DEVELOPMENT NO.:	22030349		
APPLICANT:	Arc Two		
ADDRESS:	48A SOUTH ESPLANADE GLENELG SOUTH SA 5045		
NATURE OF DEVELOPMENT:	Dwelling addition with a boundary wall located on the southern side boundary		
ZONING INFORMATION:	 Zones: Waterfront Neighbourhood Overlays: Airport Building Heights (Regulated) Affordable Housing Building Near Airfields Coastal Flooding Prescribed Wells Area Regulated and Significant Tree Stormwater Management Urban Tree Canopy Technical Numeric Variations (TNVs): Finished Ground and Floor Levels (Minimum finished groun level is 3.2m AHD; Minimum finished floor level is 3.45m AHD; Minimum Frontage (Minimum frontage for a detached dwelling is 5m; semi-detached dwelling is 5m; row dwelling is 300 sqm; semi-detached dwelling is 250 sqm; row dwelling is 200 sqm) Maximum Building Height (Levels) (Maximum building 		
LODGEMENT DATE:	5 Sep 2022		
RELEVANT AUTHORITY:	Assessment Panel at City of Holdfast Bay

ITEM NO: 5.5 REPORT NUMBER: 448/22

Above: Land of 49 South Esplanade where boundary wall will be adjacent to.

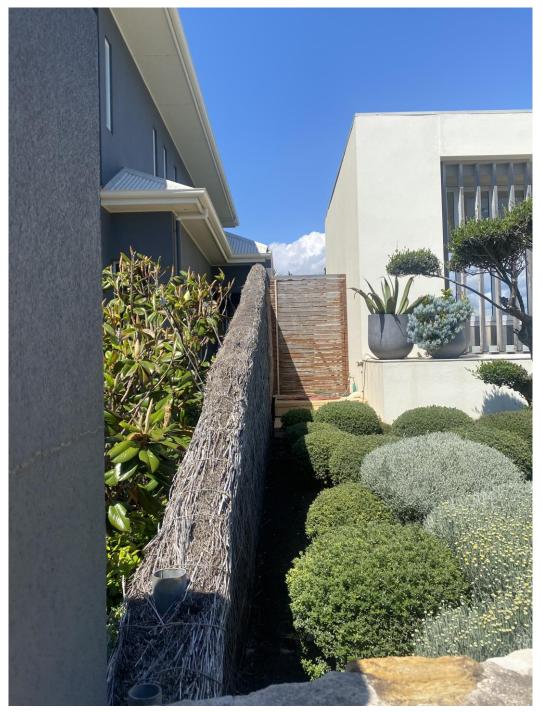
The proposed wall seeks to match the height of the existing boundary wall which is 3.12m high from the footing. There is a difference in height due to the difference in natural ground level. The ground level where the wall is proposed is stepped lower than the ground level where the existing boundary wall is located.

While the numerical policy was not satisfied, the test as to whether the height of the wall is reasonable is to determine whether PO 7.1 is satisfied. Overshadowing impacts will be negligible as there are no northern-facing windows or private open space areas that are adjacent to the wall. The addition will be adjacent to a blank wall and a side access path which is not a primary open space area. Most of the wall will be screened by the existing built form on the southern adjoining allotment therefore visual impacts will be minor. It is also worth noting that no objections were raised during the notification process.
